Addenda No. 6

SUBJECT: I-84: Multnomah Falls - Cascade Locks Section
Columbia River Highway
Multnomah & Hood River Counties
Grading, Structures, Paving, Guardrail, Pavement Markings, Signing &
Automatic Traffic Recorder Project

The following changes are made to the Project Bid Booklet:

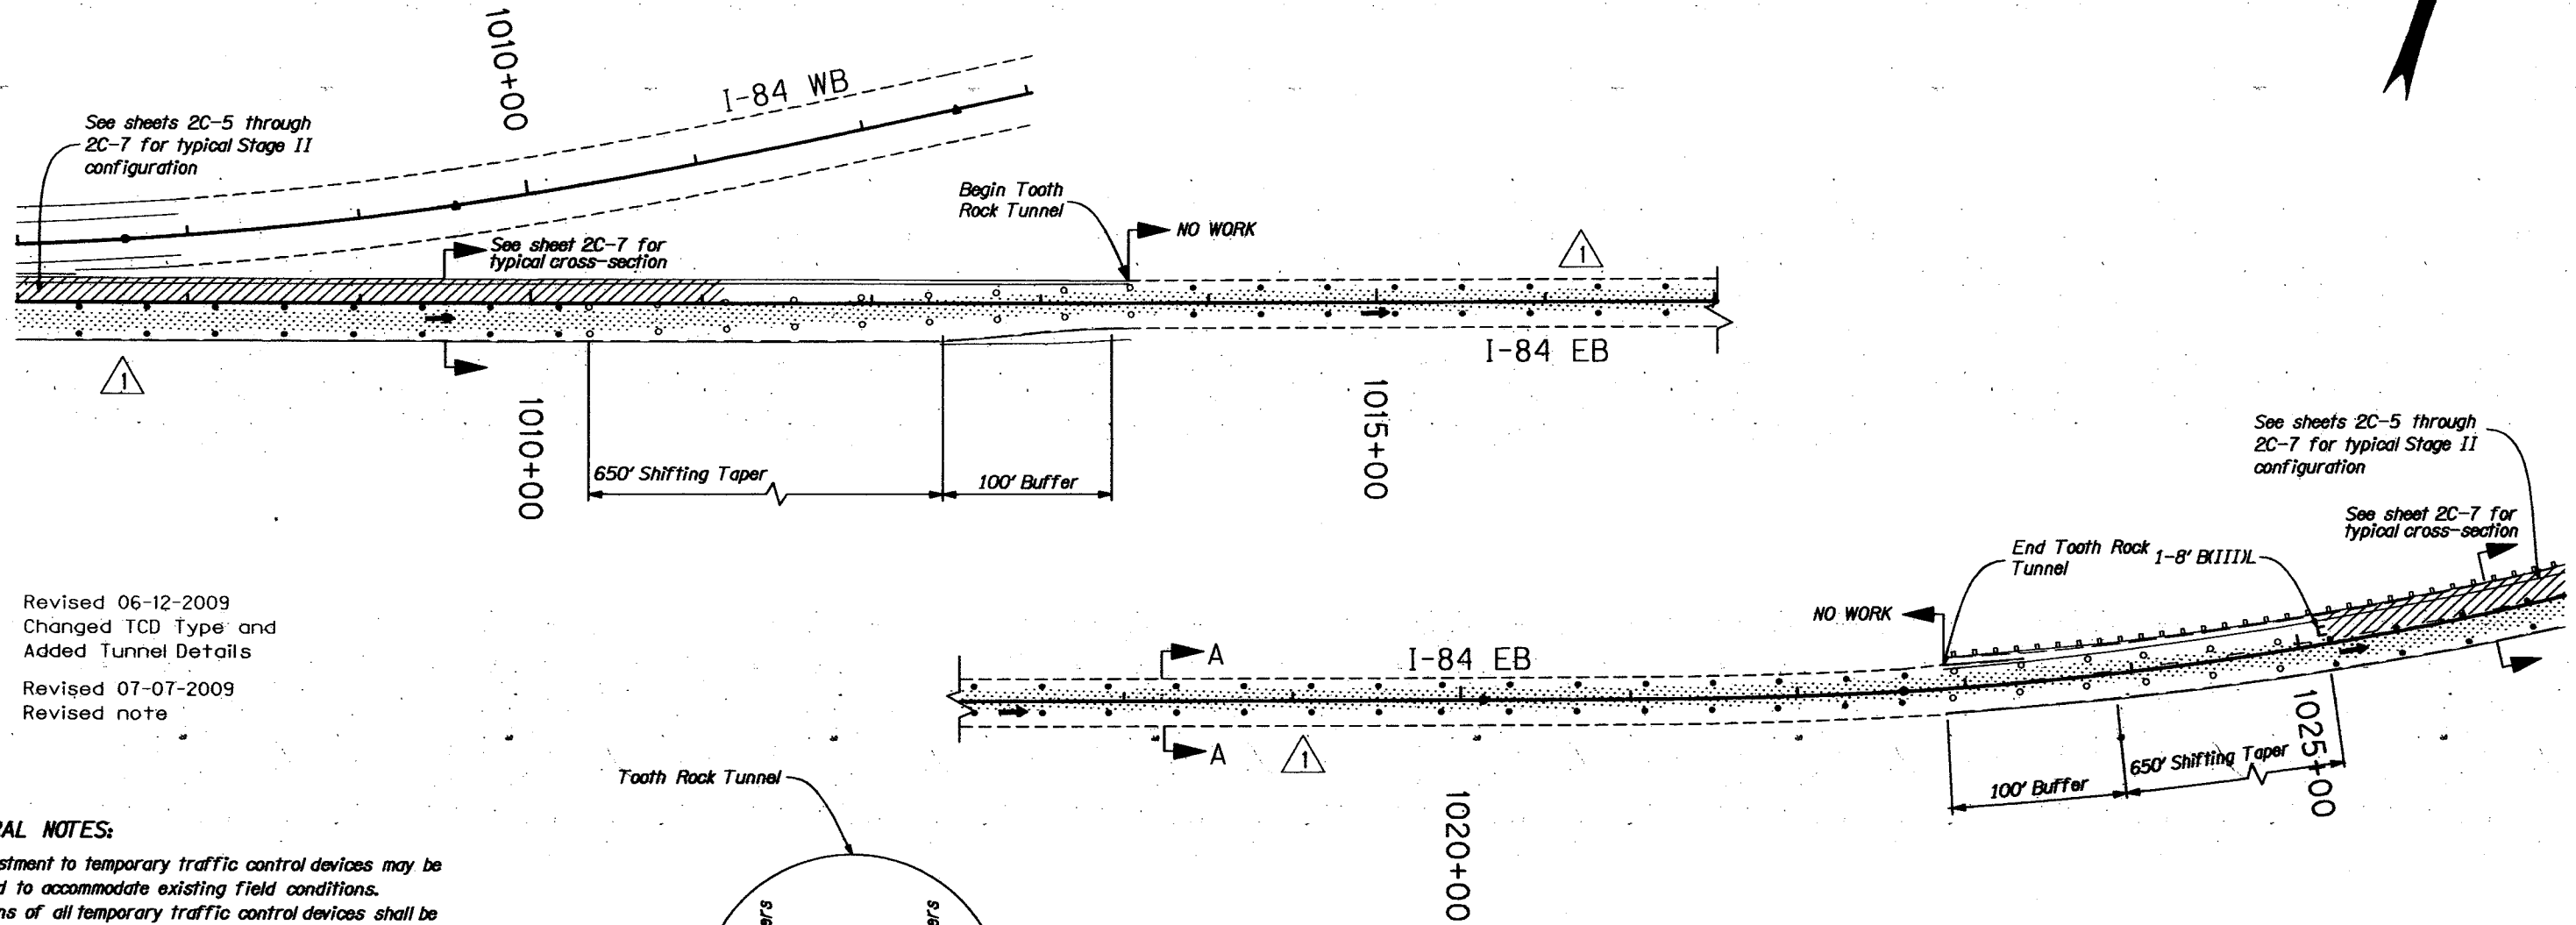
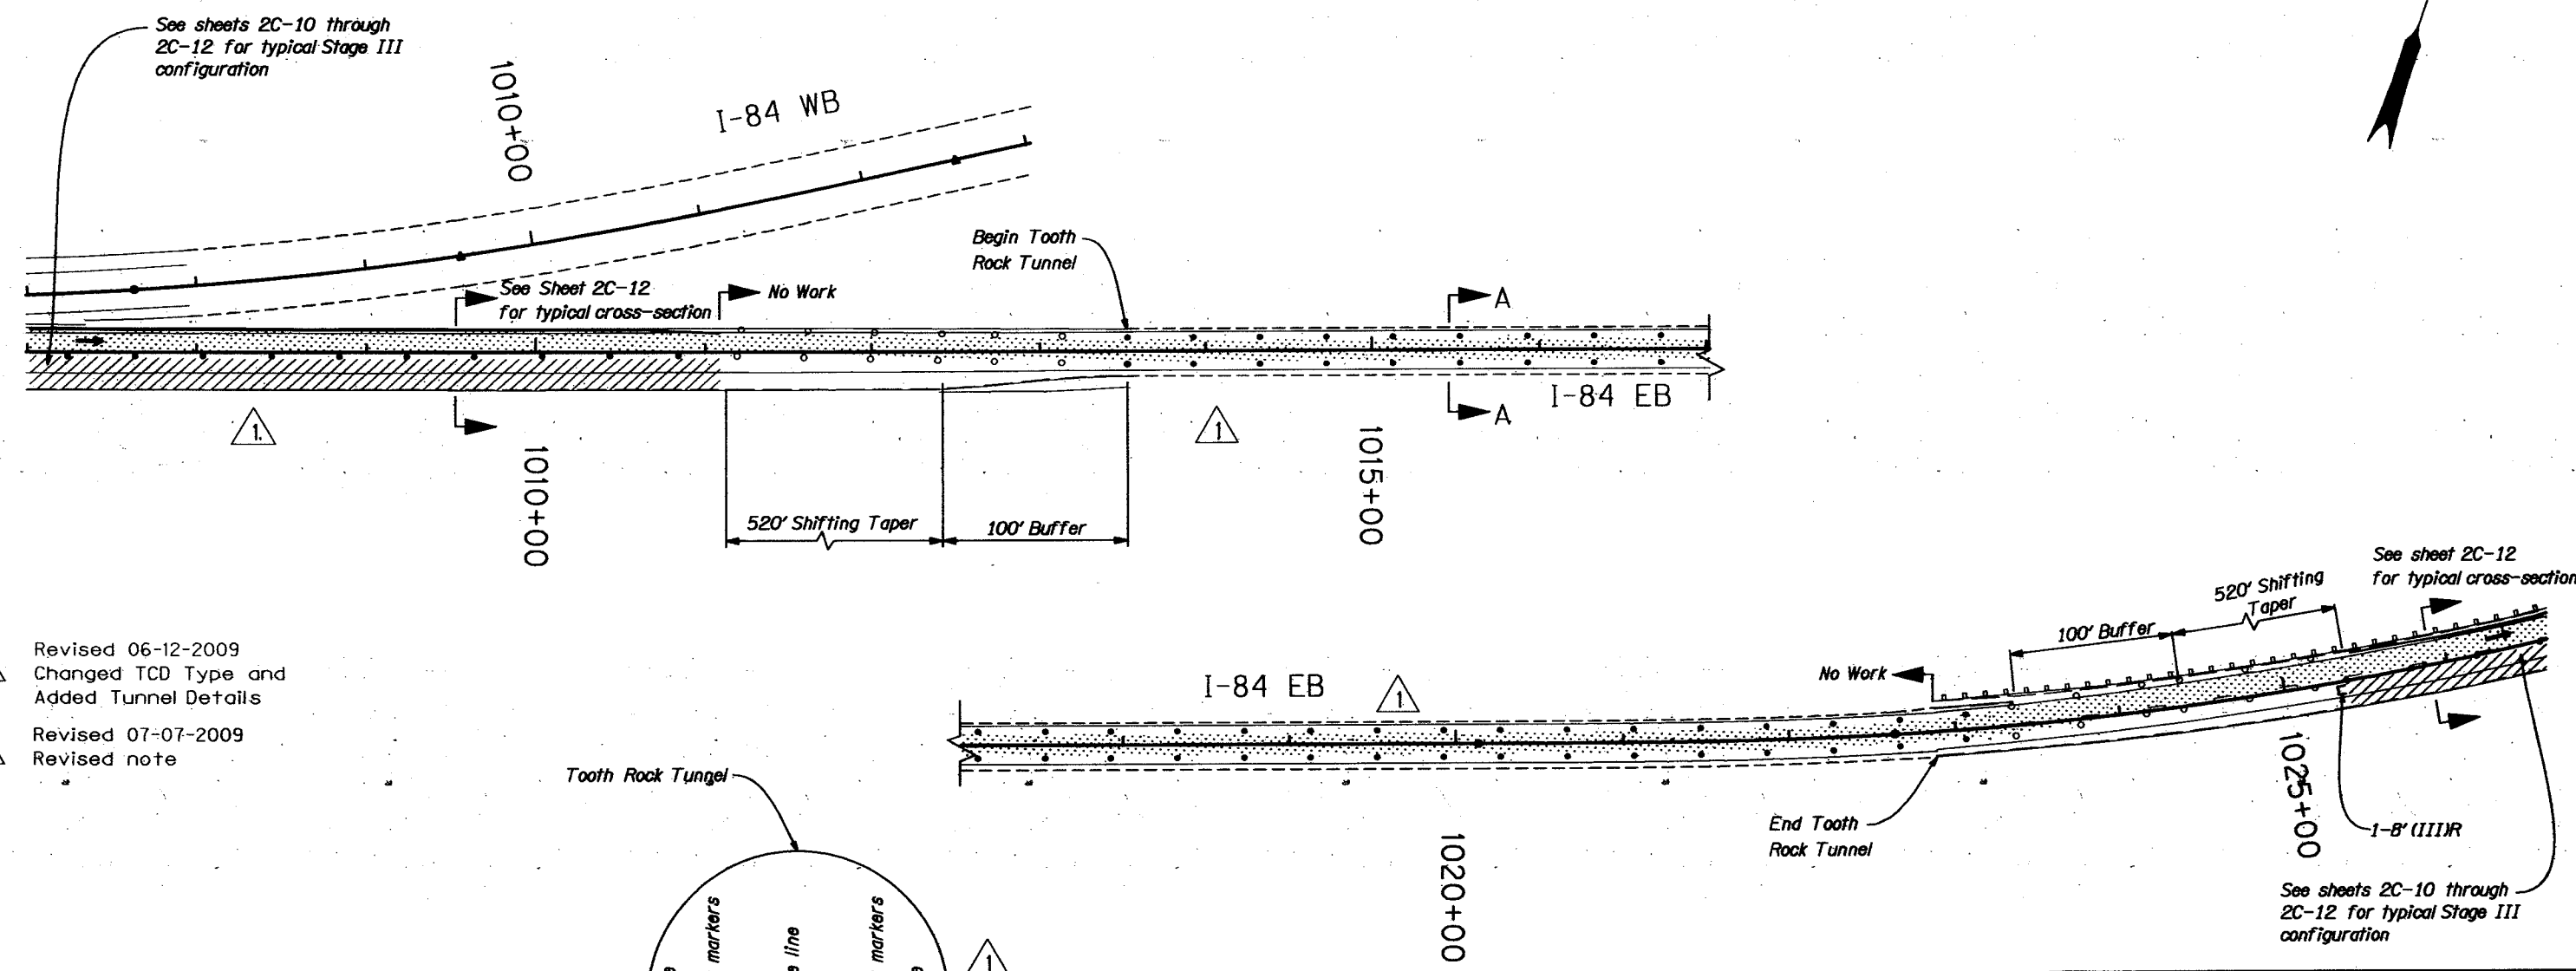
- 1 Revised 06-12-2009
Changed TCD Type and
Added Tunnel Details
- 2 Revised 07-07-2009
Revised note

- 1 Revised 06-12-2009
Changed TCD Type and
Added Tunnel Details
- 2 Revised 07-07-2009
Revised note

TRAFFIC CONTROL PLAN SHEET NO. 2C-14

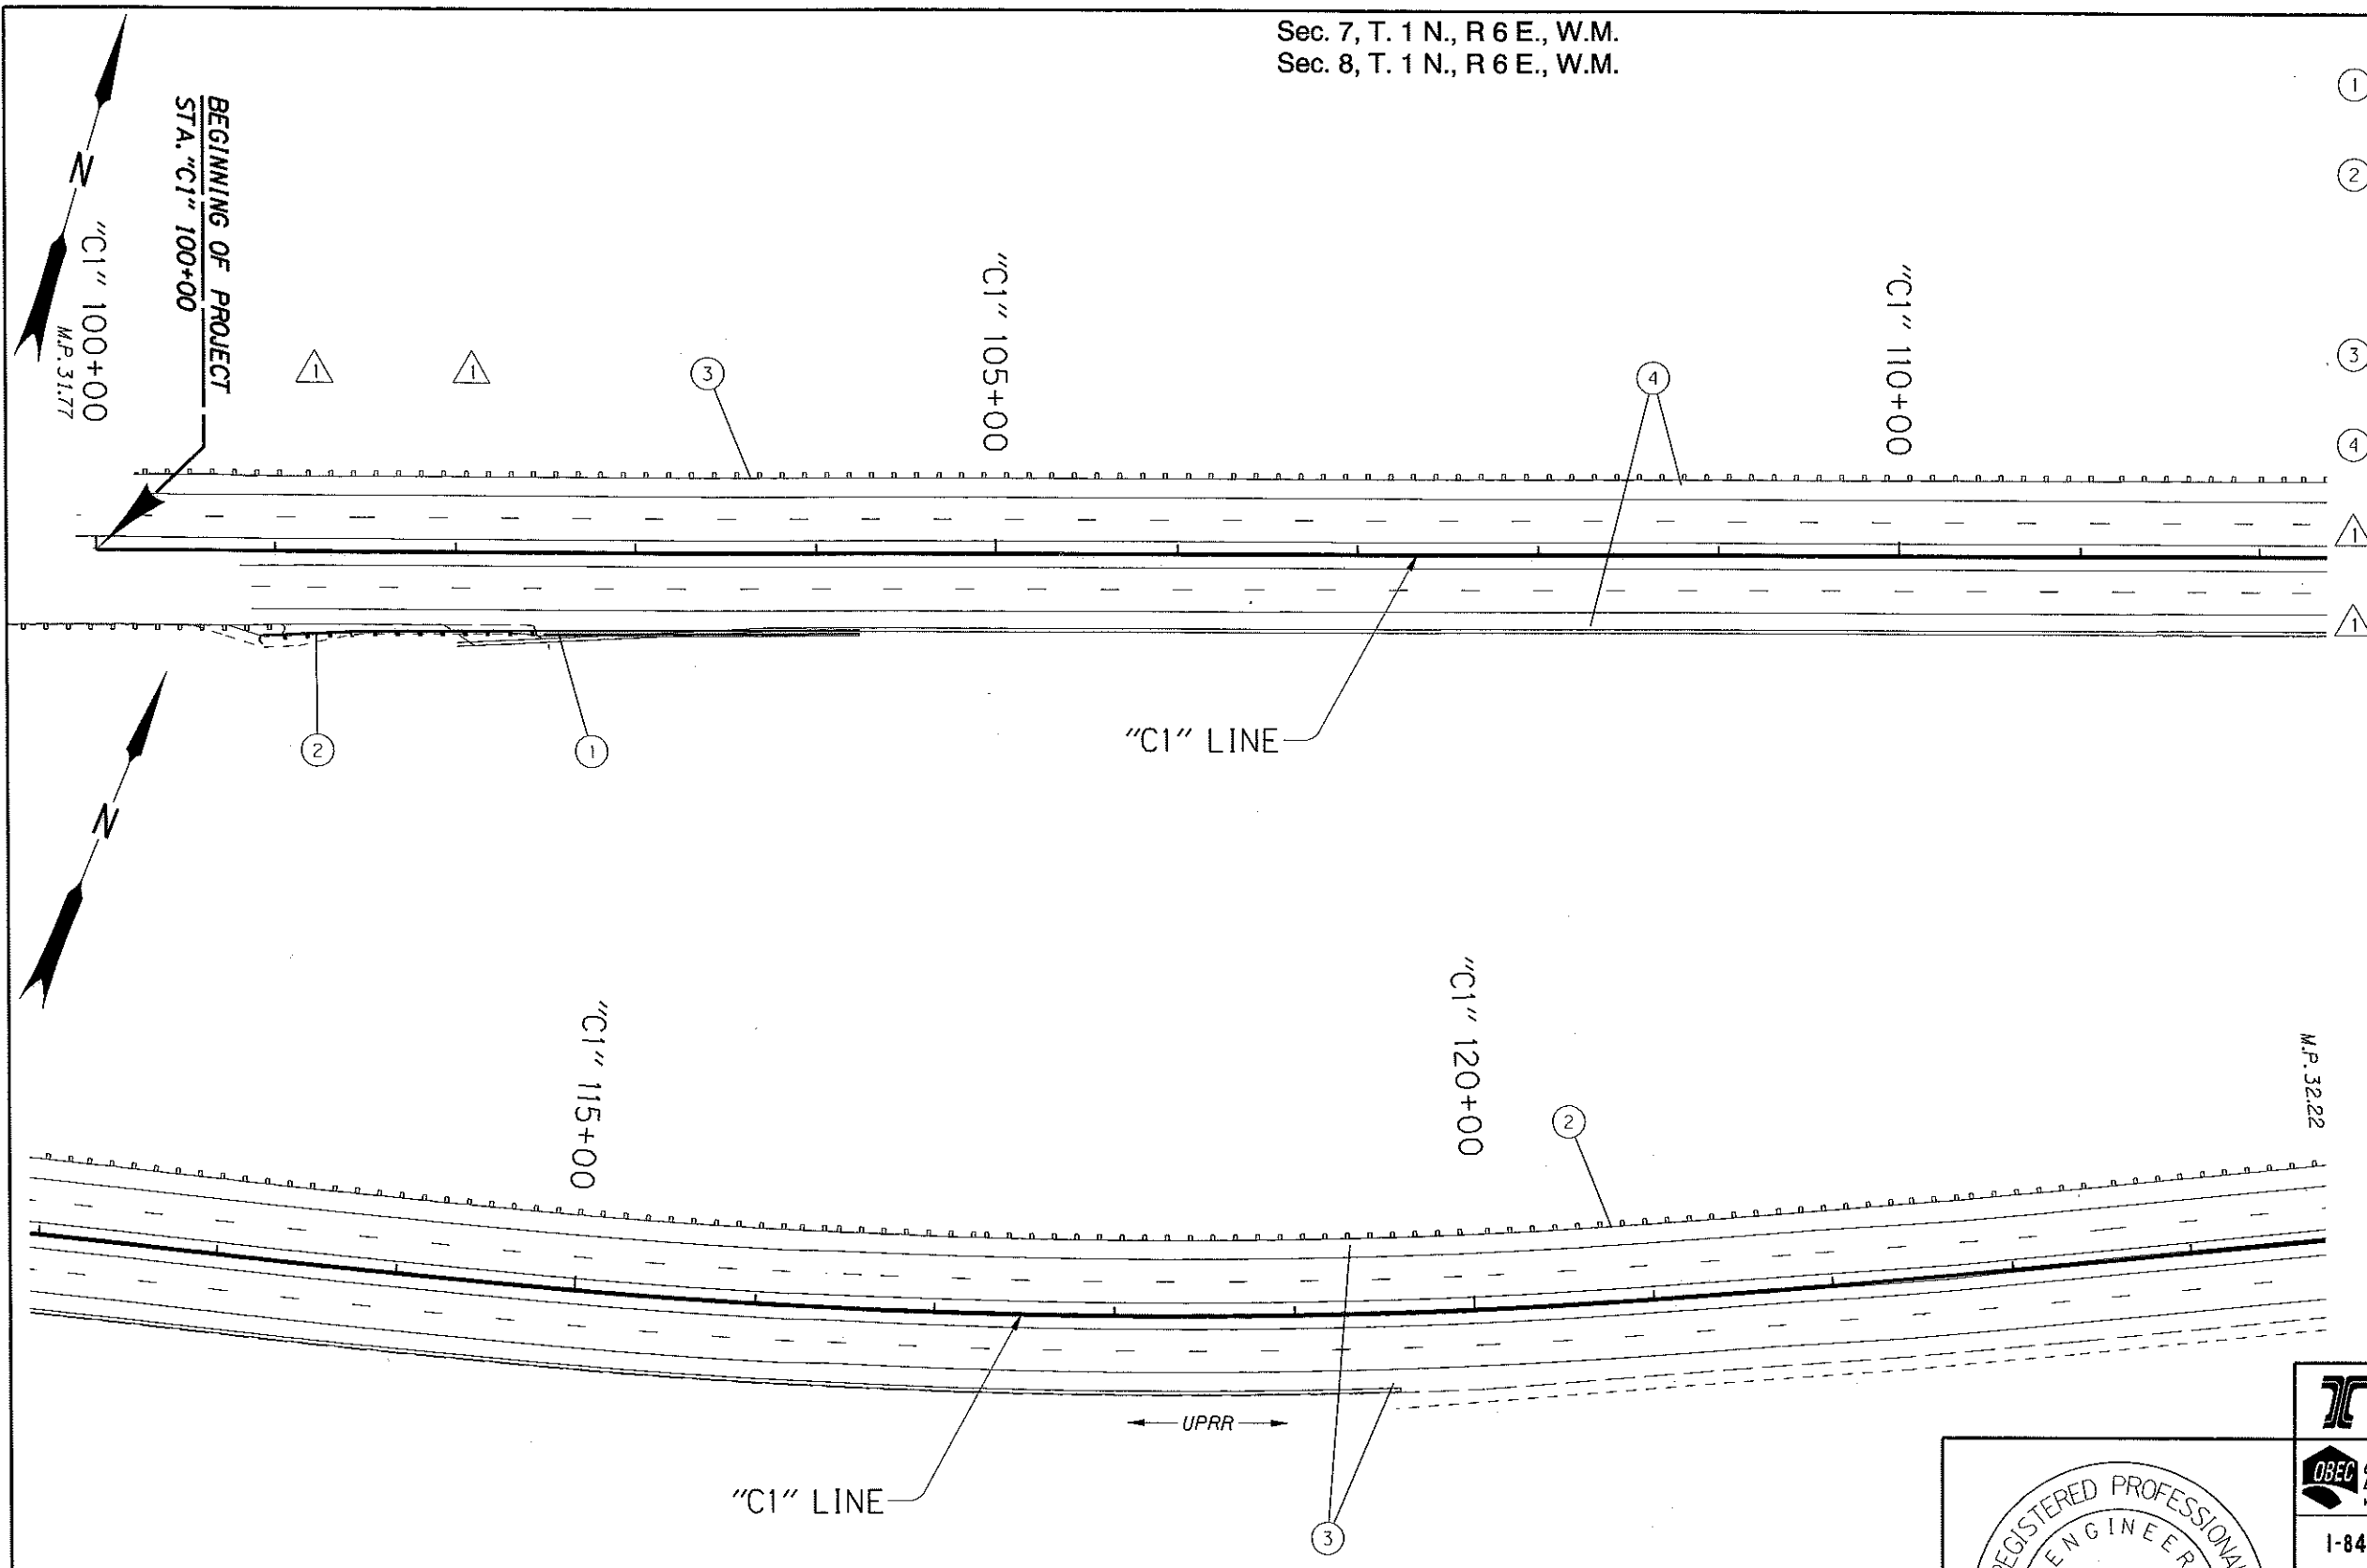
REVISIONS	
△	Revised 7-8-2009
	Removed Note
